# INITIAL FIRE SAFETY ASSESSMENT

Factory Name: **Refat Garments Ltd.**

Assessor: **Bureau Veritas**

Date: **14 Nov 2015**

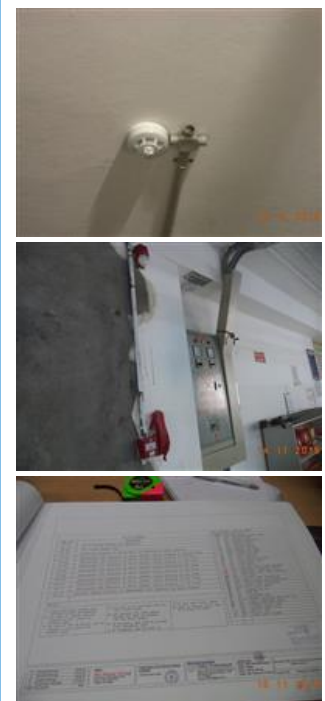
Question:	Are exit enclosures provided with fire-resistive rated construction barriers?
Priority Level:	High
Non-Compliance Level:	2
Description:	There are 5 stairs available in 6 story main building. Certified fire doors are installed at most exits. Unprotected penetration in stair-3 at basement floor and non-rated door from medical room in stair-1 was found in the same building. There are 3 stairs available in 8 story main building. Most of the exits are provided with non-rated door, though factory has already started the installation work of fire door.
Source of Findings:	Photograph: 1. Certified fire door 2. Non rated door from medical room 3. Non rated opening at basement 4. Non rated door at stair of 8 story building
Suggested Plan of Action:	Provide fire-resistive rated construction barriers and associated opening protection for exit enclosures in accordance with Alliance Standard Sections 4.5, 4.6, and 6.3.1.2. Consult a qualified fire protection engineer to design the required rated construction barrier and opening protection.

Suggested Deadline Date:	08 Mar 2016
Standard:	Reference Alliance Standards Part 4 Section 4.5 Separation
